# City of Santa Fe, New Mexico

# memo

2025-011328-HDRB, 433 Calle La Paz, Downtown & Eastside Historic District, contributing, Martinez Architecture Studio PC, agent for The John C. Gregory Revocable Trust and the Pamela S Austin Revocable Trust, owners, proposes to replace windows and doors, vigas, install wood railings, exterior stairs with hand rails, and construct a 210 sq. ft. portal to a height of 10'-6" on the main residence, install 5'-0" high fencing, and construct at 148 sq. ft. portal to a height of 11'-5", replace windows and doors, and install an overhang on the casita, and refinish the garage door. An exception is requested to 14-5.2(D)(5)(a)(i) for replacing historic windows.

Figure 8: Façade Diagram

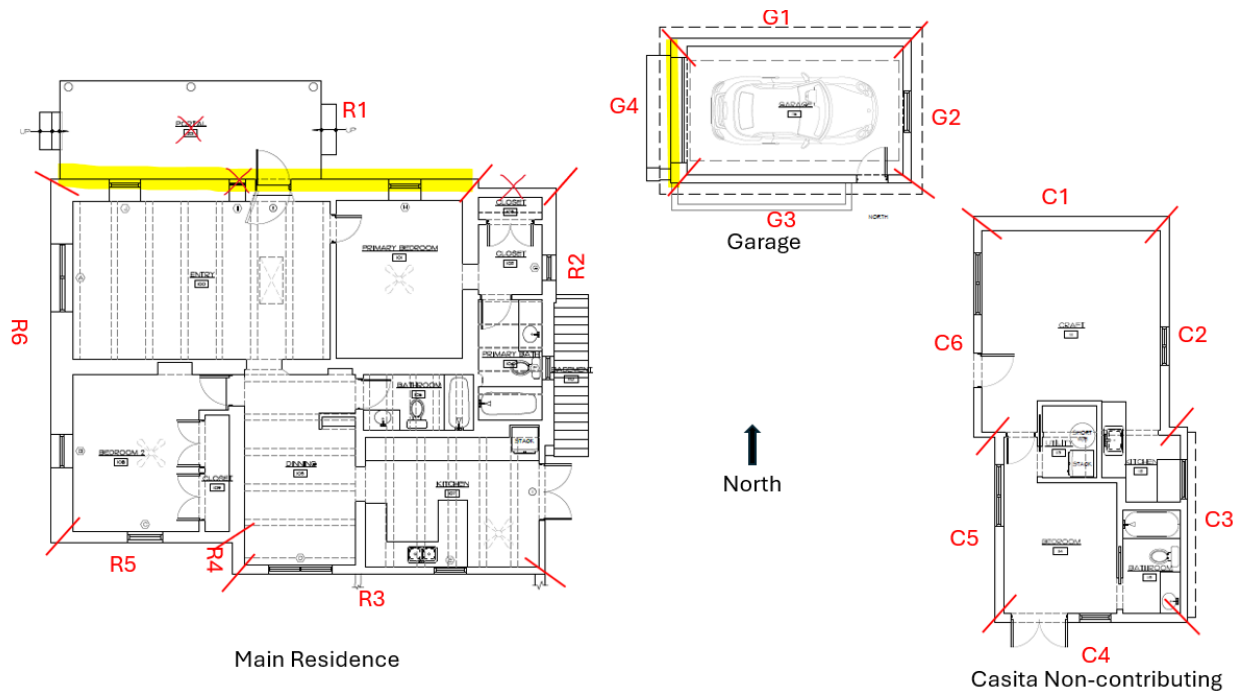
2025-010839-HDRB the Board was to maintain the main residential structure's contributing status and designated the north (R1) as the primary facade excluding the portal which appears to be new based on the HCPI that refers to non-weathered wood and a new flooring and decking, the sidelite window which per the HCPI is likely not original, and excluding the eastern addition wall which has no coping unlike the rest of the house, designated the garage as contributing with the west (G4) as the primary facade, and designated the guesthouse and yard walls as non-contributing due to their age.

Figure 9: Window Schedule

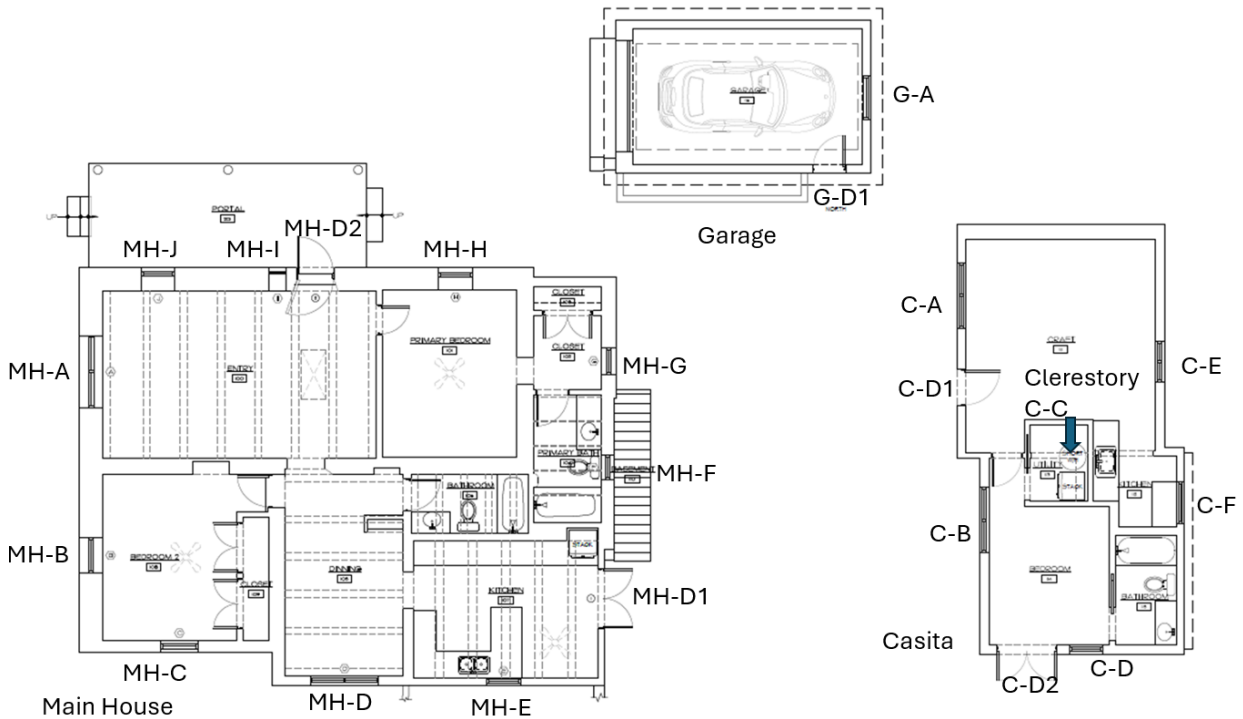
1. Replace windows and doors. An exception is requested to section 14-5.2(D)(5)(a)(i) to replace historic windows on a primary façade. The windows will be replaced with double-pane wood windows with divided lites, and sizes to match the existing windows.
  - a. North
    - i. Window MH-H 32”x 64” Double Hung
    - ii. Window MH-J 29”x 48” Double Hung
    - iii. Window MH-I14”x 51” fixed (excluded from the primary façade designation).
  - b. West
    - i. Window MH-A 71”x 38” fixed barn sash
    - ii. Window MH-B 32” x 64” Double Hung
  - c. East
    - i. Window MH-F 26” x 32” double hung 2015 clad
    - ii. Window MH-G 21” x 31” fixed barn sash

- iii. Door MH-#1 wood frame door 60" x 81" clad 2015 will be replaced with a wood sliding divided lite door.

Exception to Section 14-5.2(D)(5)(a)(i): The applicant requests an exception to replace historic windows on a primary façade.

Applicant Response: The applicant desires to replace the deteriorated single-pane windows because of their single-pane construction and water infiltration. The applicant desires to replace the windows as part of their effort to maintain the contributing home as a viable part of the historic district without changing the appearance of the primary facade. Denying the exception would preclude the applicant's efforts, to their detriment, and result in the continued deterioration of the walls and the windows, ultimately injuring the condition of the home and the public welfare.

Staff Response: Staff finds that this criterion is met. The replacement windows will appear in kind and will not damage the character of the district.

Staff Response: Staff finds that this criterion is met. Per the window assessment: "Windows B & H and J are historic; however, there are signs of water penetration underneath the sills of the windows, causing structural integrity damage to the adobe. The windows would need to be removed to properly flash the openings to stop the water penetration. The window jambs are the buck in the openings. Removal of the window would destroy the jamb and cause the historic window to be non-reusable and non-restorable. Window G is historic; however, rotted beyond 40% and is non-restorable. Windows and doors A, C, D, E, DR #1, F, and I are non-historic." Replacing windows that allow water penetration is necessary to avoid further damage to the contributing building.

Staff Response: Staff finds that this criterion is met. Replacing windows that allow water penetration is necessary to avoid further damage to the contributing building and allow for continued use of the residence.
